In re: K237FC, Dallas, TX
BMPFT-20160712ABR
Facility ID No. 150497

This refers to the above-captioned minor change application for K237FC.

Overlap attachment:

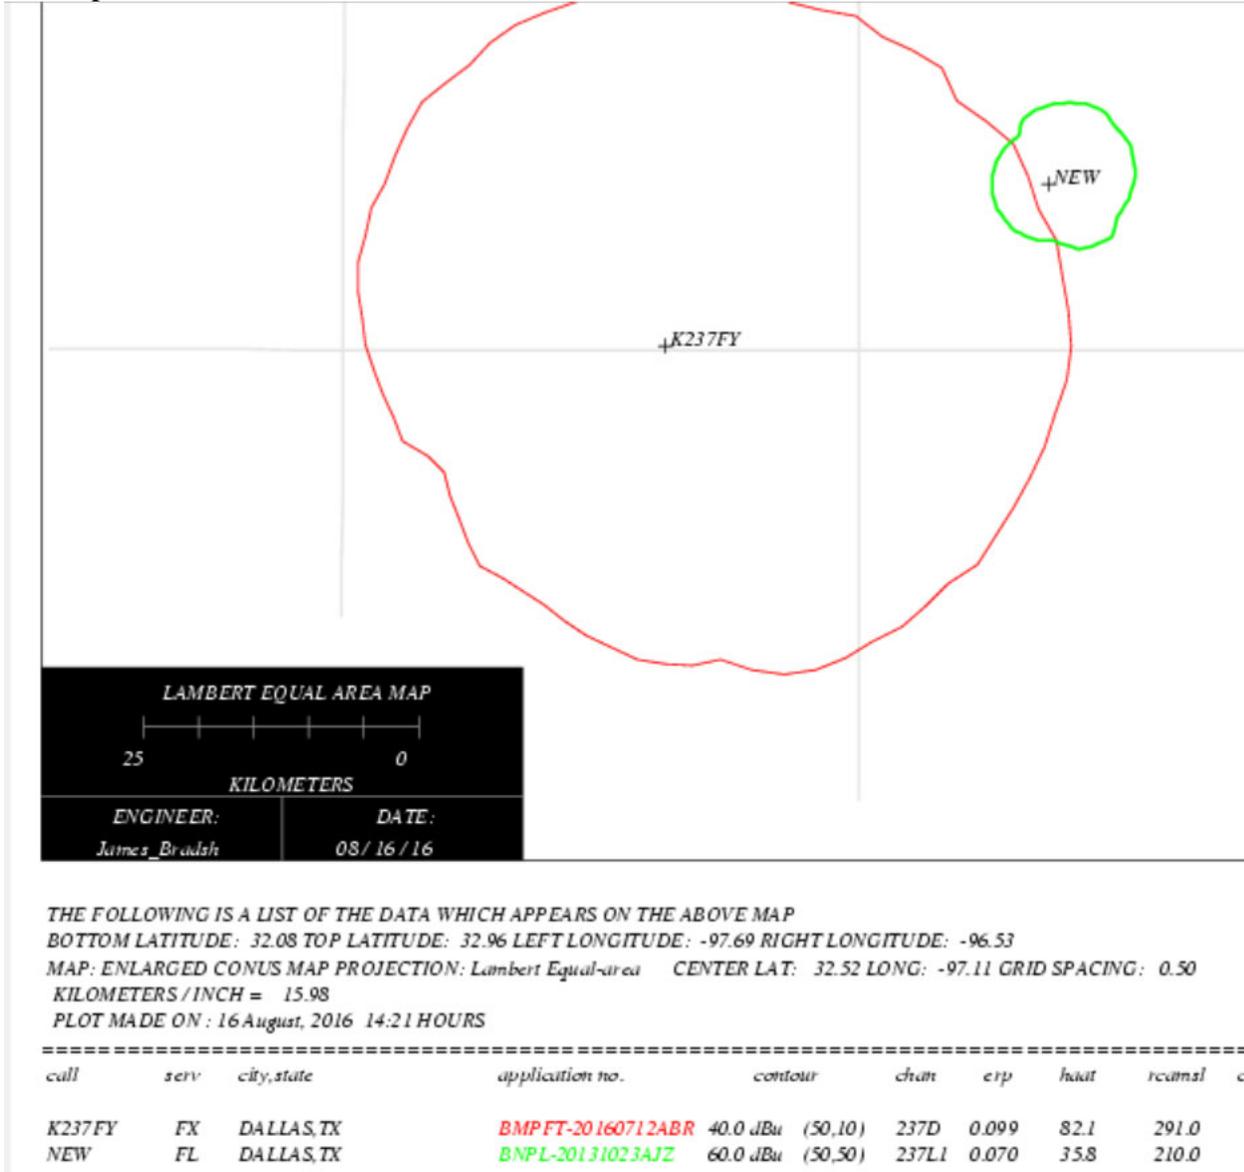
An engineering study reveals the application is in violation of the interference protection requirements of 47 C.F.R. Section 74.1204. Specifically, the proposed 40 dBu interfering contour overlaps the 60 dBu protected contour of the facilities of a co-channel LPFM construction permit for a KVWR-LP, Dallas, Texas (BNPL-20131023AJZ). The application does not recognize this defect. Accordingly, we dismiss the application as unacceptable for filing.

Red contour: K237FY, BMPFT-20160712ABR – 40 dBu interfering contour

Green contour: KVWR-LP, Dallas, TX BNPL-20131023AJZ – 60 dBu protected contour

In light of the above, application BMPFT-20160712ABR is unacceptable for filing pursuant to 47 C.F.R. § 73.3566(a) and IS HEREBY DISMISSED. This action is taken pursuant to 47 C.F.R. § 0.283.
